VARIANCE REQUEST

Iowa Department of Natural Resources

1. Date: September 26, 2007
 2. Review Engineer: Larry Bryant
 3. Date Received: September 20, 2007
 4. Facility Name: City of Nashua
 5. County Number: 19 (Chickasaw)
 6. Program Area: CP (Wastewater Construction)
 7. Facility Type : C01 (Collection/Transport)
 8. Subject Area : 344 (Pump Clogging Protection)
 9. Rule Reference: 567-64.2(9)a
 10. Design Stds Ref: 13.4.2 (Protection Against Clogging)
 11. Consulting Engr: MSA Professional Services
 12. Variance Rule: 567-64.2(9)c

Re: Charles City Road Pump Station Trash Basket Variance Request
MSA Project No.: 4910601

1 SECTIONAL VIEW
CS8

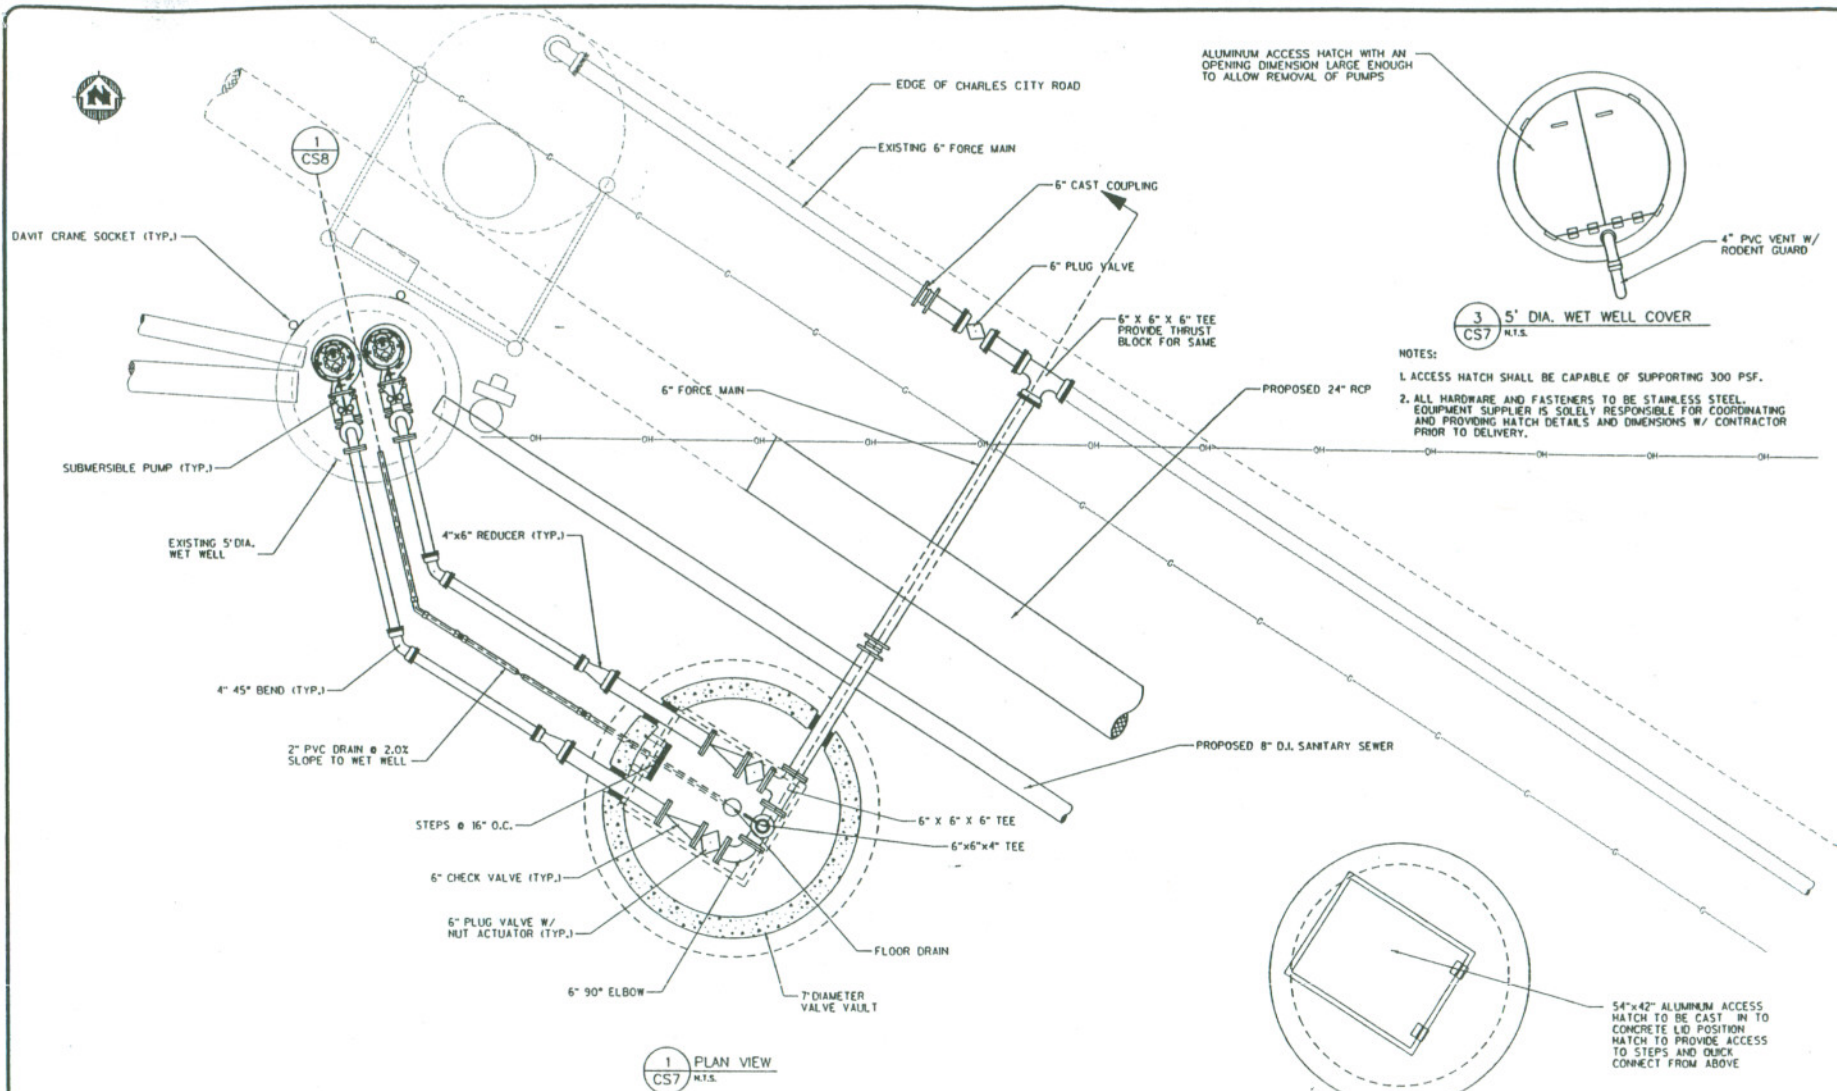
"Due to the size of the wet well, installing trash baskets within the structure will prevent the pumps from being removable. Furthermore, the existing pump station does not have trash baskets installed within the wet well and has operated without any plugging. The proposed pumps to be installed can pass a 3-inch sphere, which should alleviate any plugging concerns. In addition, the bypass that discharges to the lake will be plugged with non-shrink grout, which would prevent floating material and screenings from discharging into the lake."

Due to the size of the wet well, installing trash baskets within the structure will prevent the pumps from being removable. Furthermore, the existing pump station does not have trash baskets installed within the wet well and has operated without any plugging. The proposed pumps to be installed can pass a 3-inch sphere, which should alleviate any plugging concerns. In addition the bypass that discharges to the lake will be plugged with non-shrink grout, which would prevent floating material and screenings from discharging into the lake.

1. As noted by the consulting engineer, placement of trash baskets to cover both inlets to the existing wet well would obstruct pump removal at ground surface. Also, the flow line of one of the influent sewers is low and a trash basket would be intermittently submerged during normal operation.

2. The existing lift station has operated without screening since 1962. The operator has noted that there has been only one bypass from this lift station during his tenure, which was due to a power failure, not pump clogging.

3. 10-States Standards and currently proposed revisions to the Iowa standards do not require (but do recommend) screening for pumps handling wastewater from sewers less than 30" in diameter. The summed capacity of the two 8" sewers served by this lift station is significantly less than that of a 30" diameter sewer.

4. Remote alarm notification and an emergency pump quick connect are provided as part of the project and the overflow at the lift station will be plugged.
